ECR/Documents for Information and Approval

Giulia Romagnoli and Natalya Kahn for BE-EA, 2024-02-13

HiRadMat Primary Vacuum Manifold

User Requirement for the XCRVH Micro-Collimator in H8 Line in North Area

Figure 3: Layout of Primary vacuum lines (extracted from SPSXMUSR0523).

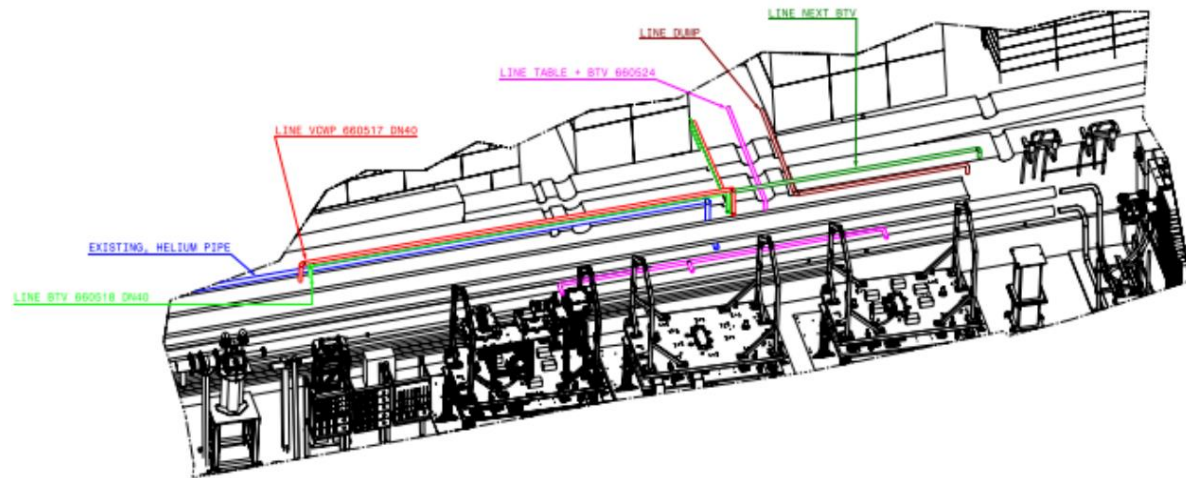
Thanks to Anthony and the VSC colleagues for the excellent work.
Please add the dump (SPTED__004-CR000001 / Position TED.660529) in impacted systems in paragraph 4.1

Figure 3 – General mechanical drawing of an XCED [2]

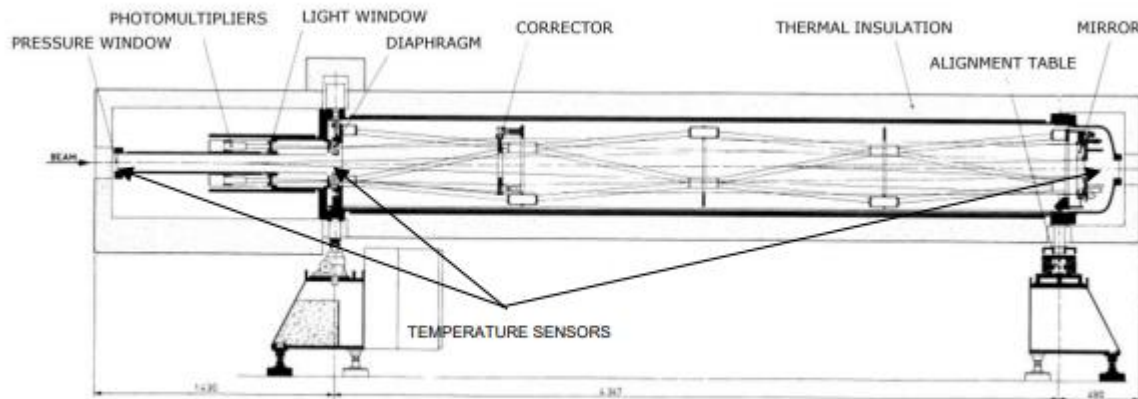
Error with references under Safety Aspects

reference of the CEDAR consolidation document ([EDMS 2742855](#)) should be added in section 2.2.

Error with reference in section 2.3

Thanks a lot for the very complete document.
some links to the safety references links are broken (table in page 10) as well as the link in the paragraph 2.3 "schedule and roles"
